FOOD LION, INC.
PROPOSED FOOD LION STORE
RIDGE ROAD (FM 740) @ FM 3097
ROCKWELL, TEXAS

REVIEW OF THE SITE PLAN FOR FOOD LION STORE

RE: Food Lion Site Plan

Agenda Item: P&Z 09-23/SP/PP - Discuss and Consider Approval of a Site Plan/
Preliminary Plat/Building Plan for Food Lion Grocery Store

JOB NO.	90-96
DATE	7/6/90
DRAWN	M.T.B.
CHECK	D.F.
SHEET	A-3
OF 16	
EXTERIOR ELEVATIONS

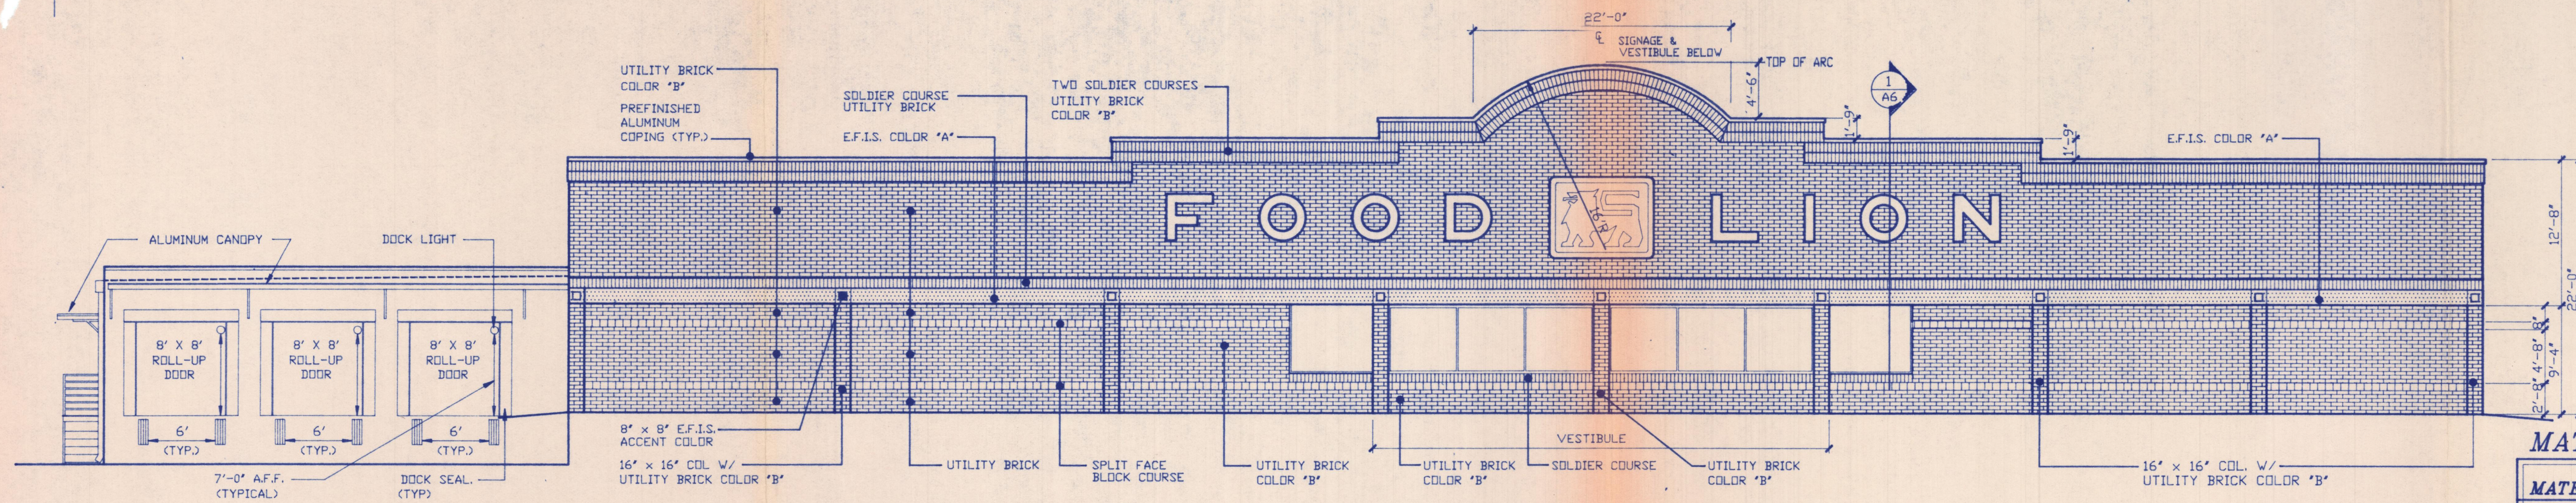
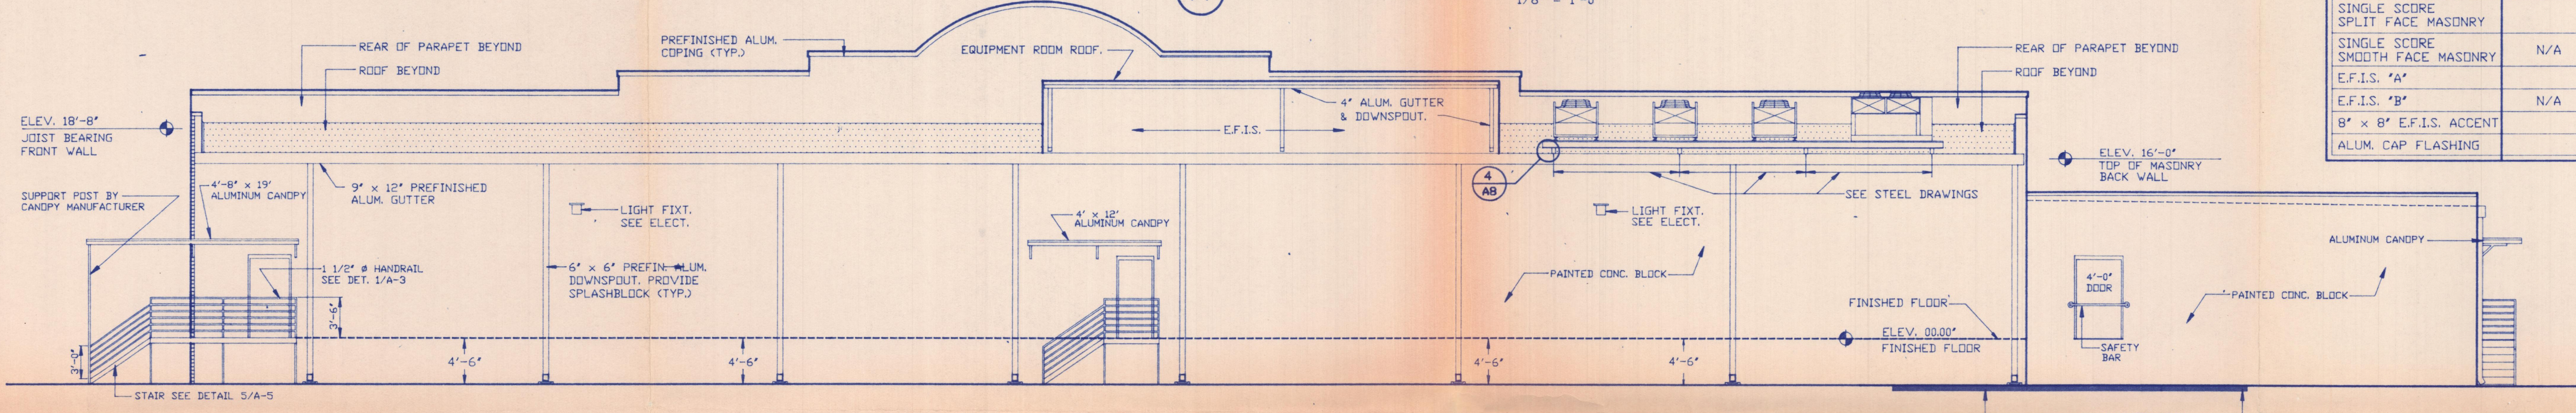
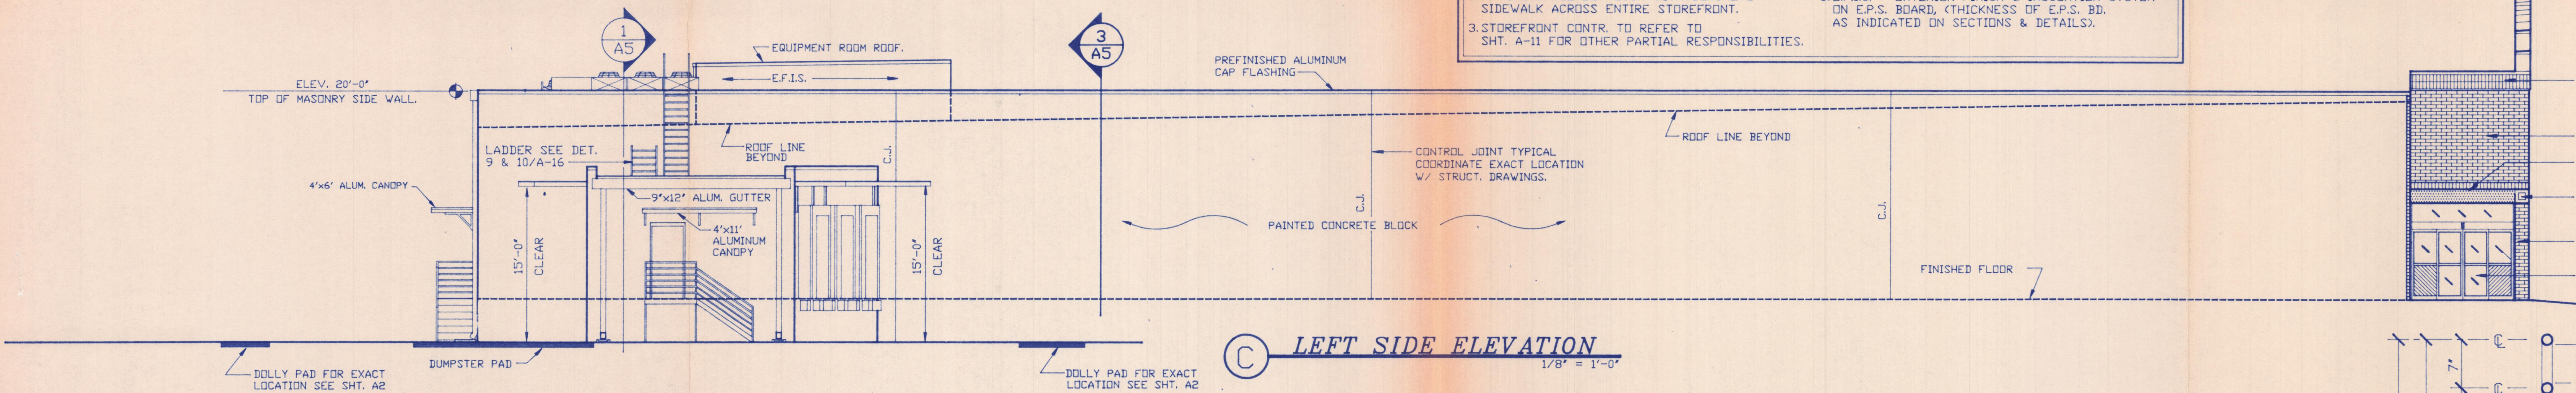
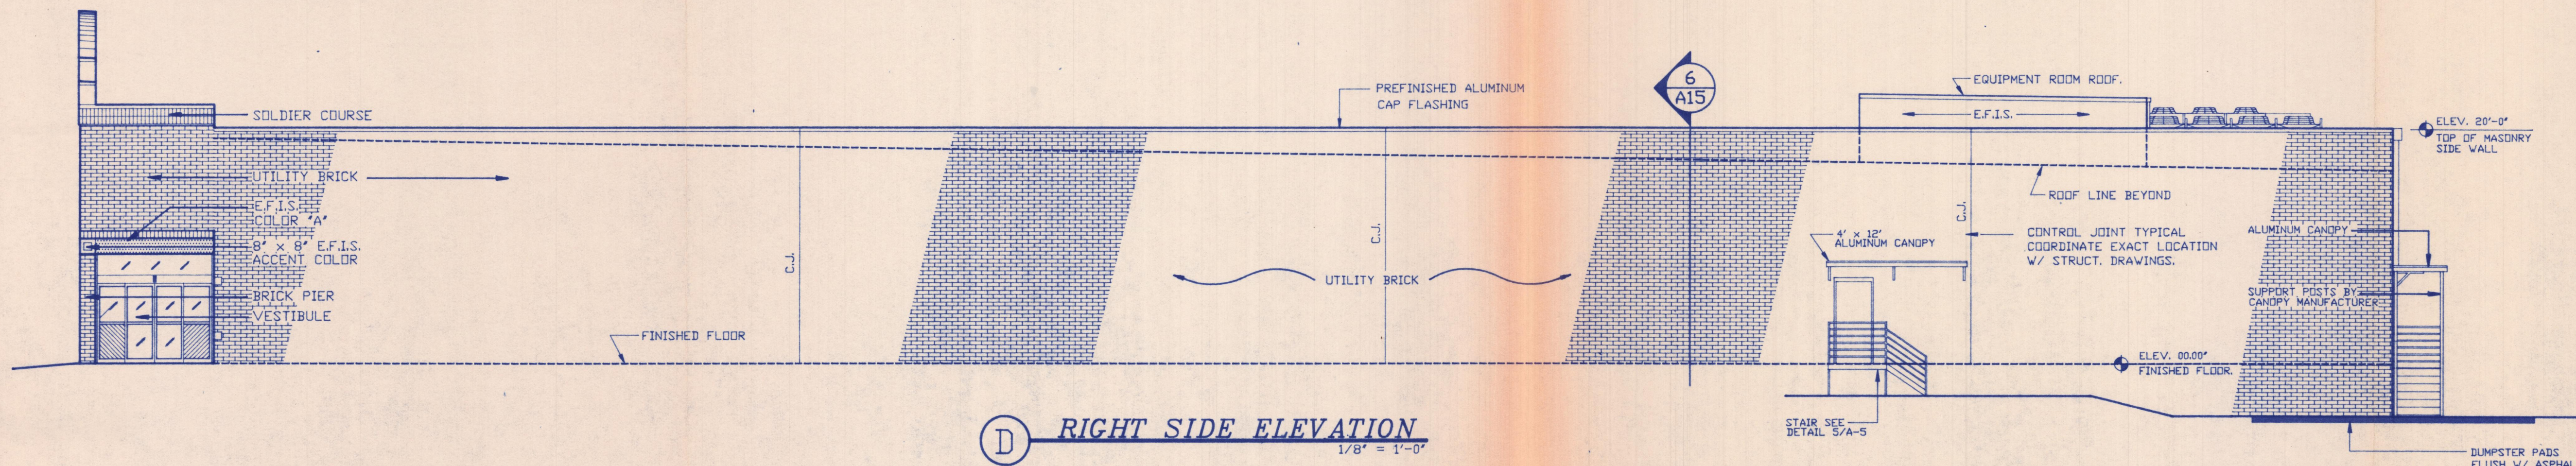
9. The parapet at the two front corners of the building should be wrapped around from the front to the sides to add some mass and break up the visual appearance of the front parapet.

8. The parapet wall should be extended along the back of the building.
9. The parapet at the two front corners of the building should be wrapped around from the front to the sides to add some mass and break up the visual appearance of the front parapet.

The developer has removed the stucco type screen and has extended the parapet along the back of the building. This change is reflected in the revised elevations. As a point of information, the parapet is not as high as the screen was proposed to be and the top of the mechanical equipment is visible over the top of the parapet.

The developer had some initial concerns about this issue, but they believe it can be addressed. The elevations do not reflect this change, but they hope to have a proposed solution by Monday.

The developer has no problem with this and the bands are now reflected on the revised elevations.

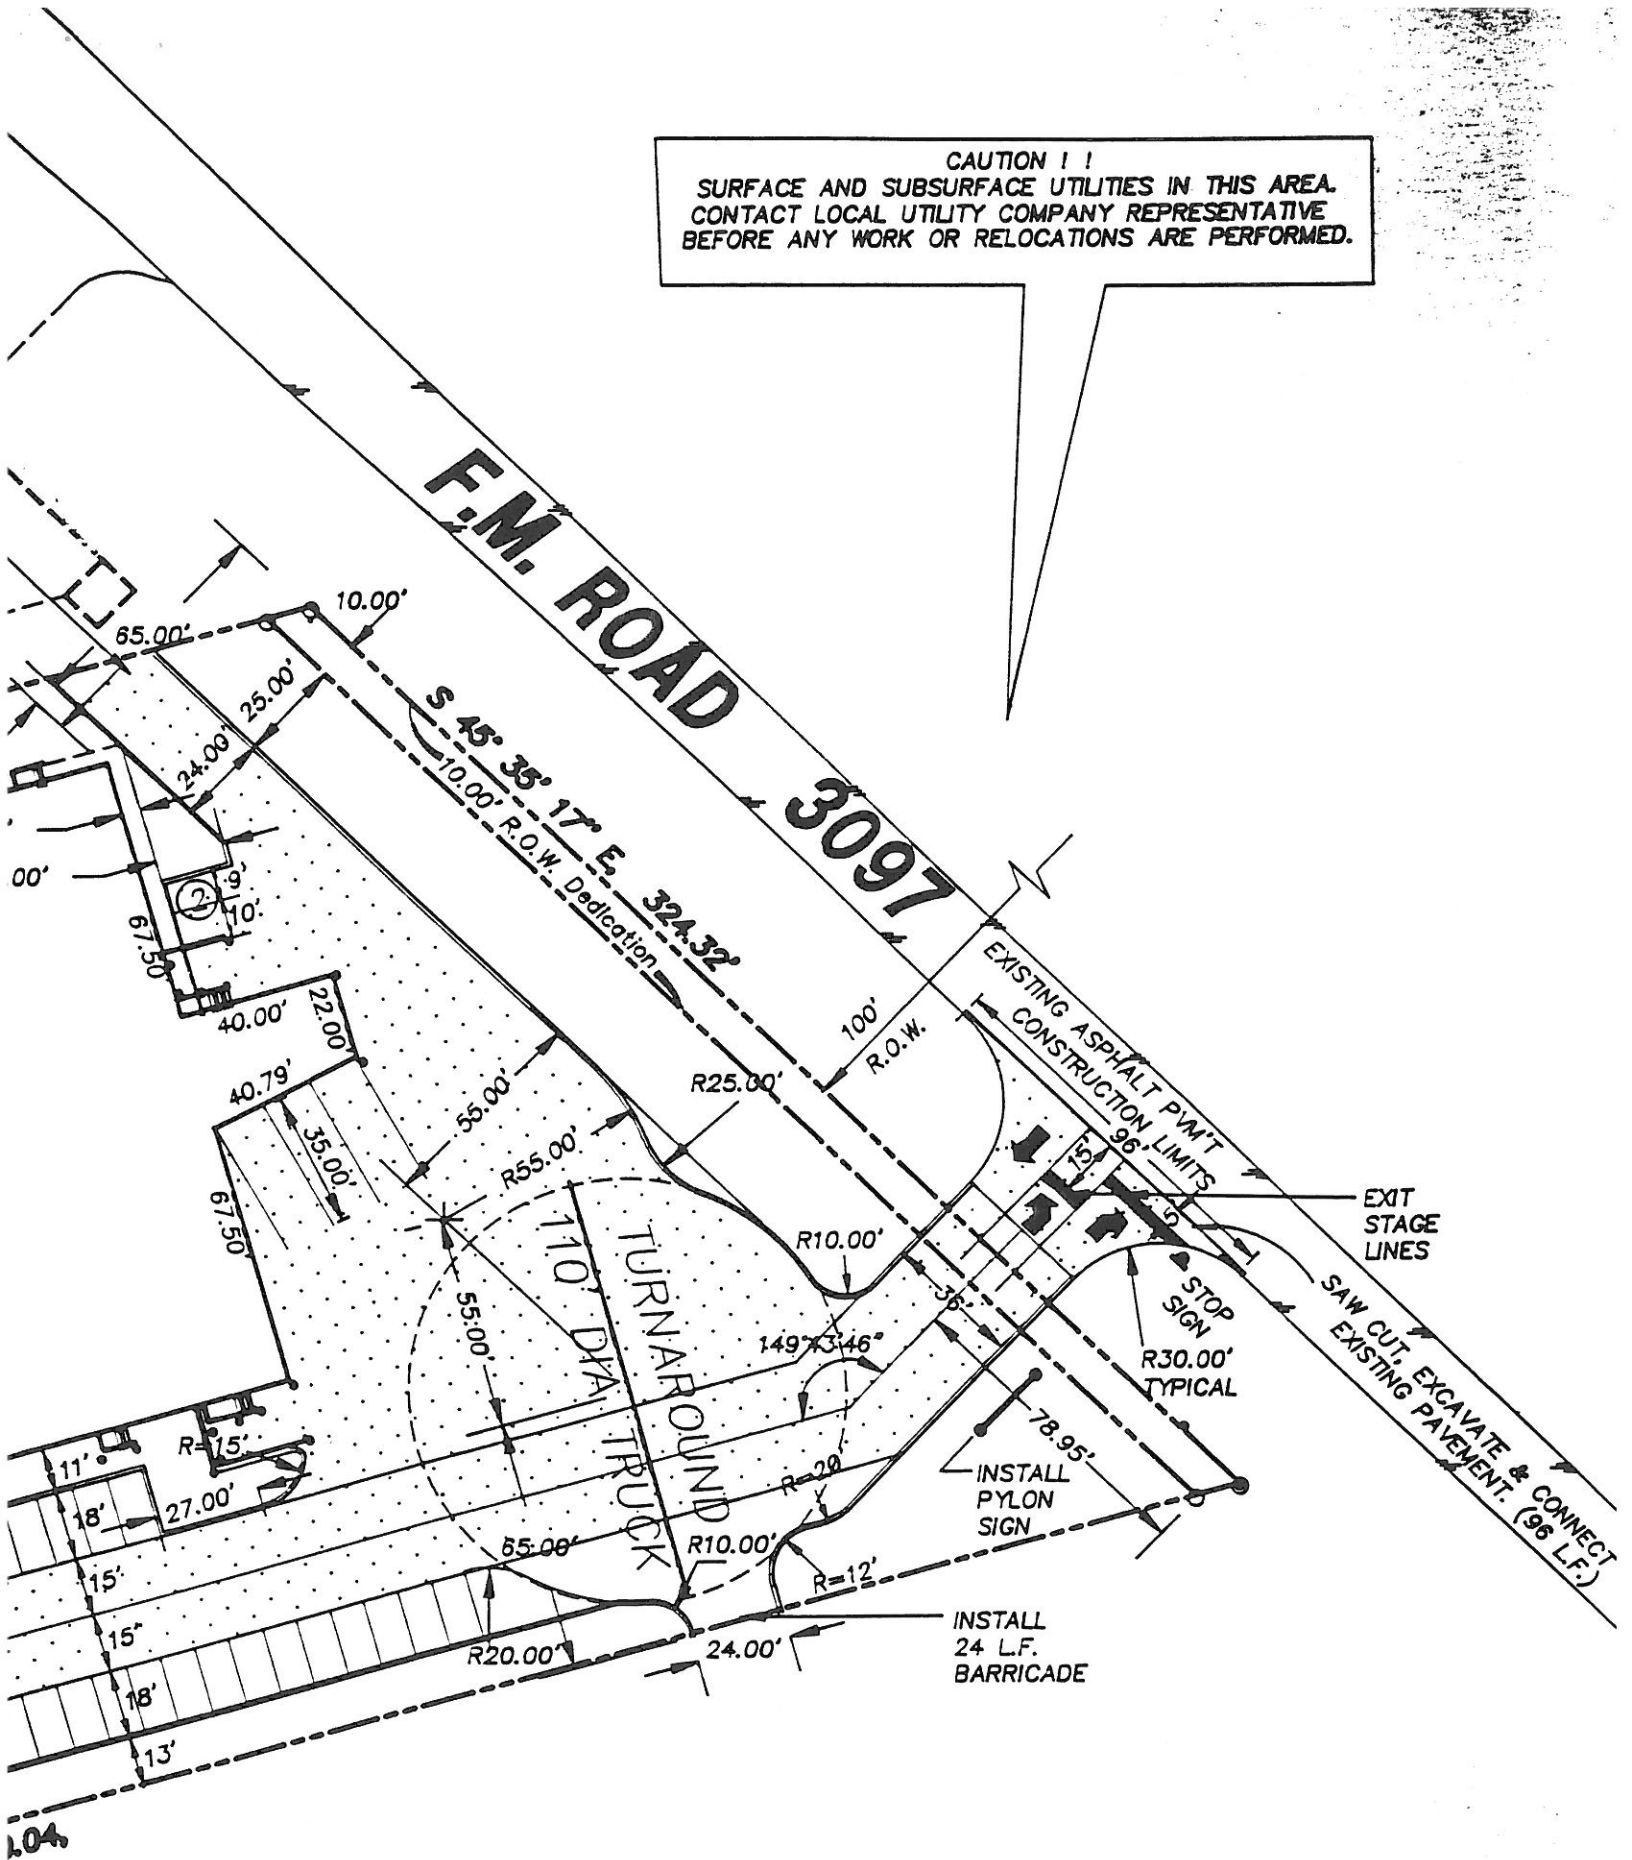
In follow up to our telephone conversation last week I would like this letter to serve as a request in considering a 36.00 foot wide drive in lieu of a 30.00 foot wide drive at our project entrance off of F.M. 3097. The attached exhibit shows the requested widening. This request was prompted by the Site Developer in order to provide better patron and truck accessibility off of F.M. 3097. This drive widening along with the proposed widening of F.M. 740 should greatly entrance the traffic conditions at the F.M. 740 site entrance. Although we do not intend to restrict truck traffic from the F.M. 740 drive we do anticipate the more convenient truck entrance and exit condition to be at F.M. 3097. Thus relieving the storage and exiting condition at the F.M. 740 Drive.
